# Request for Class II Permissive Change

FCC ID: YZZGXP1400 Data:December 11, 2011

#### 1. Added two AC Adapter as below:

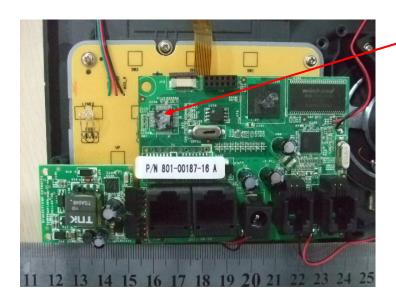
Original AC Adapter	Input	100-240VAC ,50/60Hz 0.2A
	Output	5VDC, 800mA
	Model	AK00G-0500080UW
	Brand name	All-Key(AK)
New AC Adapter #1	Input	100-240VAC ,50/60Hz 0.15A
	Output	5VDC, 800mA
	Model	SCF0500080A1BA
	Brand name	Mass
New AC Adapter #2	Input	100-240VAC ,50/60Hz 0.2A
	Output	5VDC, 800mA
	Model	SWN006S050080U1
	Brand name	Swtec
